167 DC - 194 Duncan Creek Rd., Lillington, NC 27546

**PLAN 1
The Clayton - LH
'CRAFTSMAN'
ELEVATION**

3-20-24 - Initial Redlines - JJ

SCALE:
1/8" = 1'-0"
SHEET
1.1c

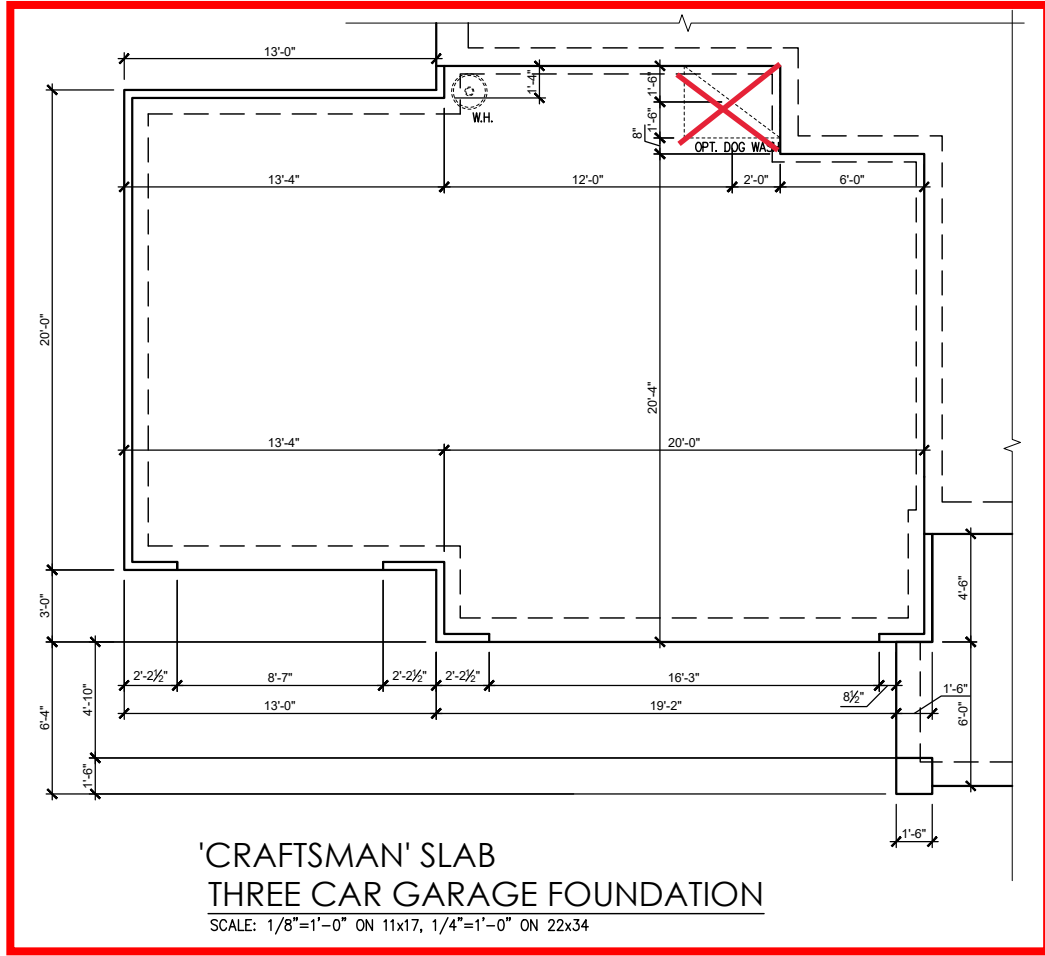
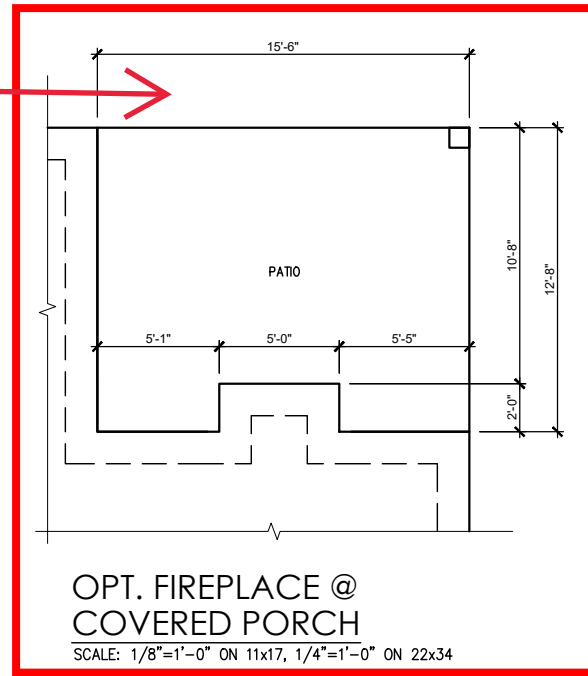
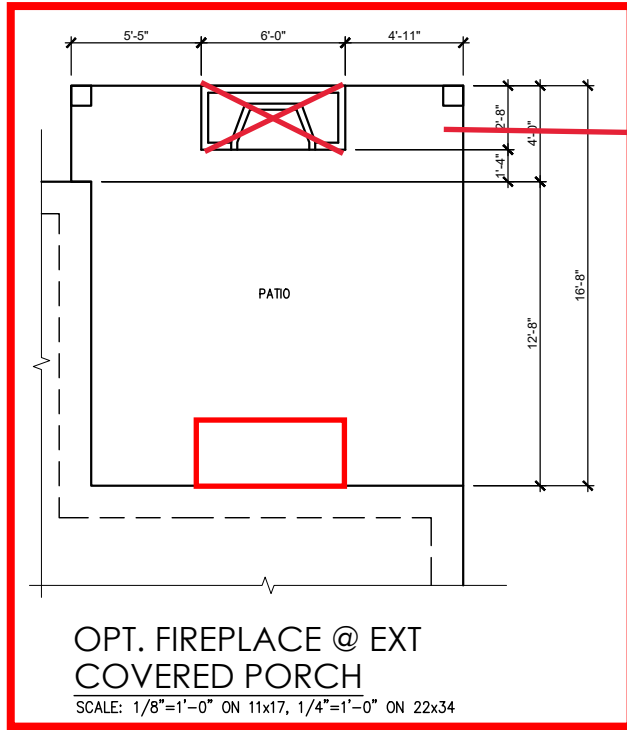
See Sheet S-1.1.1c for third car garage

OPT. 4' COVERED PATIO EXT.
OPT. COVERED PATIO
Covered PATIO
See Sheet 1.1.1c for extended porch

SCALE:
1/8" = 1'-0"
SHEET
2.1c

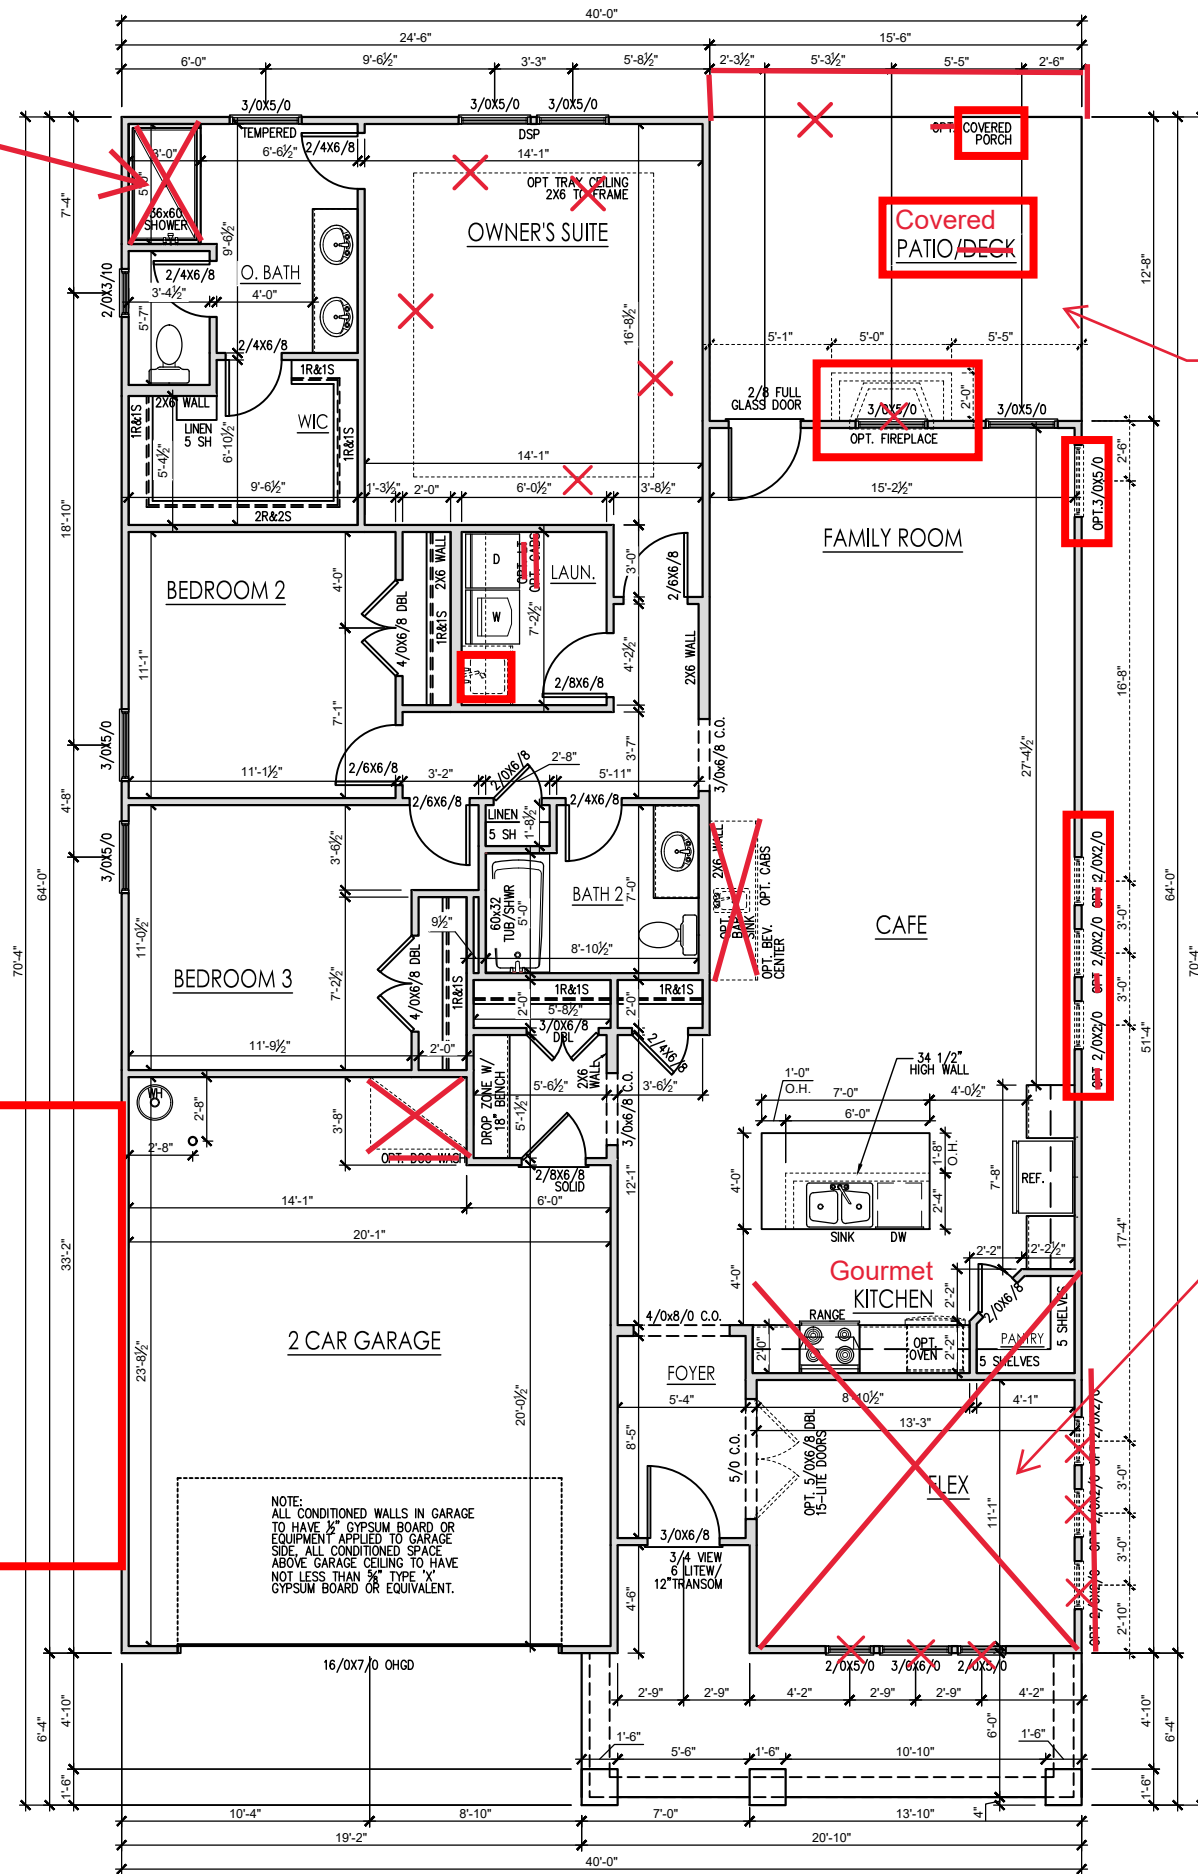
See Sheet 2.1.1.c for shower w/ seat

See Sheet 2.1.3c for third car garage

See Sheet 2.5c for ext. cov. porch

See Sheet 21.1c for pocket office & messy kitchen

**OPT. 3-CAR GARAGE
REAR ELEVATION (SLAB)**
 SCALE: 1/4" = 1'-0" ON 22x34, 1/8" = 1'-0" ON 11x17
 SEE FOUNDATION PAGES FOR FOUNDATION TYPE

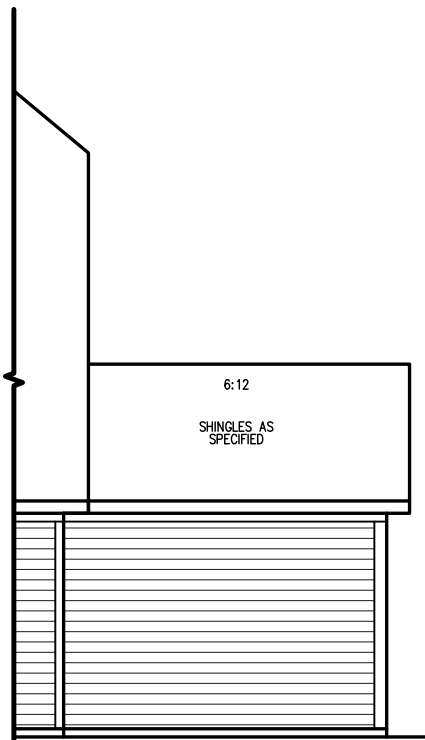
See Sheet
3.1c for
correct front

NO SECOND FLOOR
SLAB FOUNDATION PLAN 'CRAFTSMAN'
 SCALE: 1/8"=1'-0" ON 11x17, 1/4"=1'-0" ON 22x34

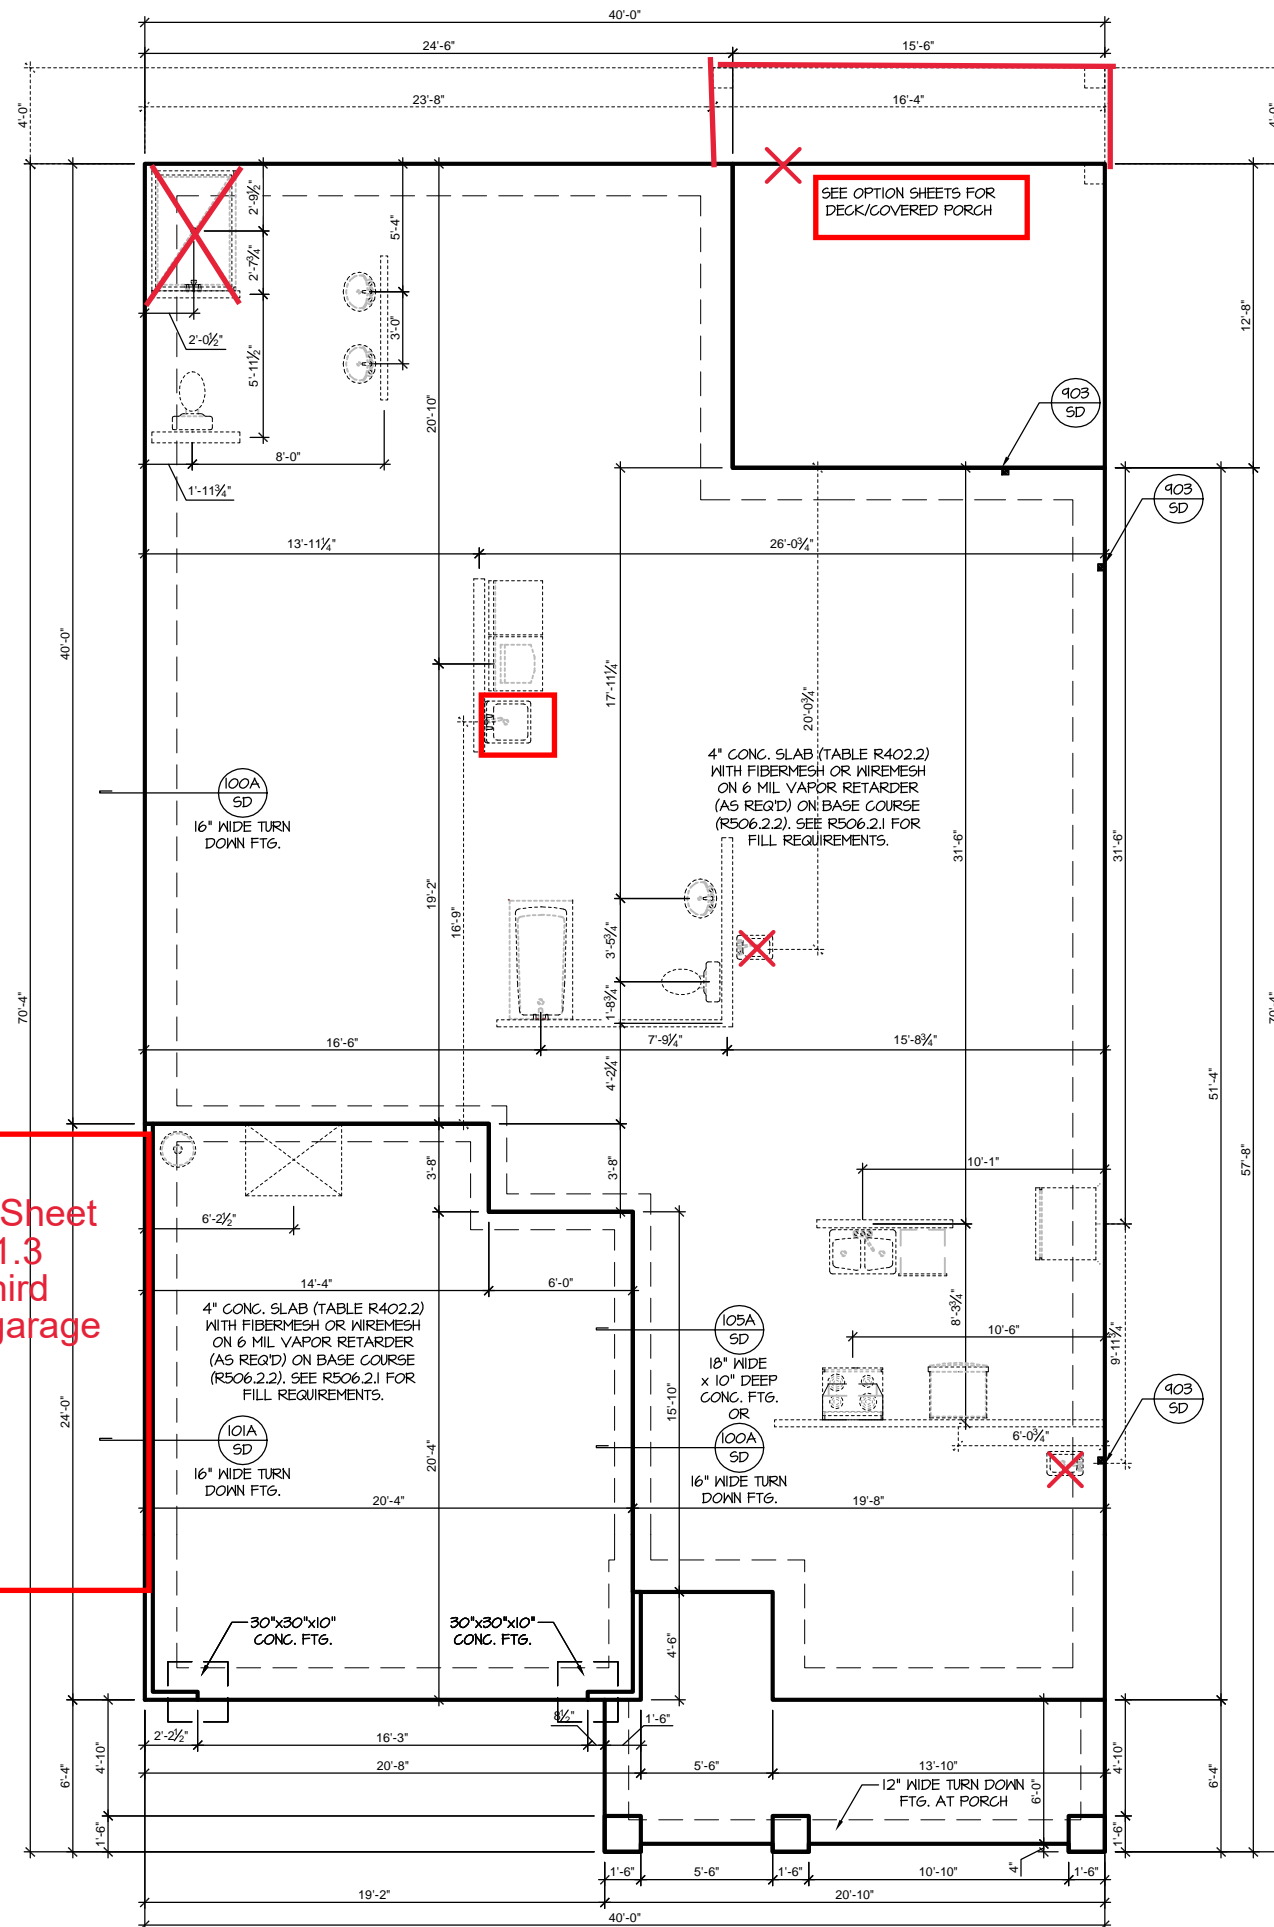
See Sheet
 S-1.1.3
 for third
 car garage

'CRAFTSMAN' ROOF PLAN
SCALE: 1/4" = 1'-0" ON 22x34, 1/8" = 1'-0" ON 11x17

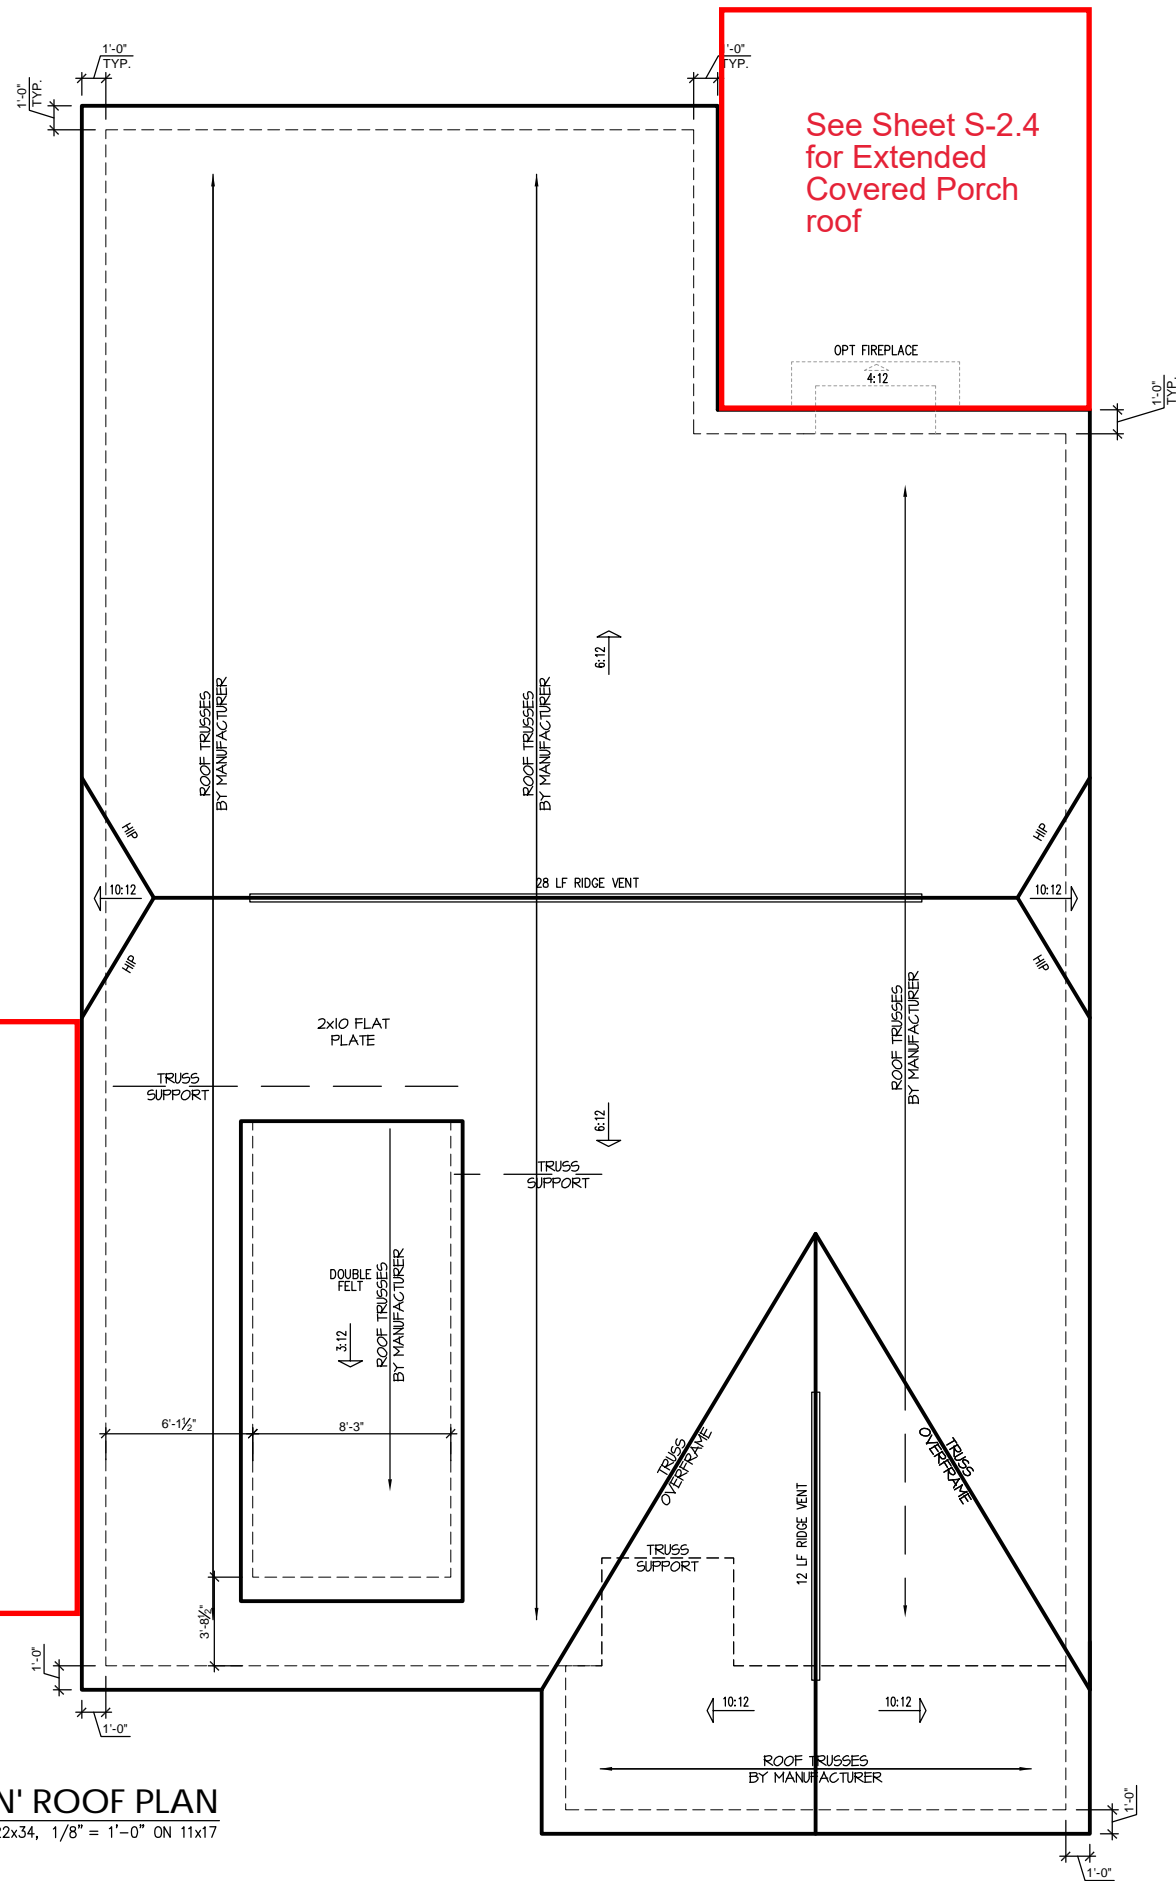
See Sheet S-2.4
for Extended
Covered Porch
roof

See Sheet
S-3.2 for
third Car
Garage
Roof
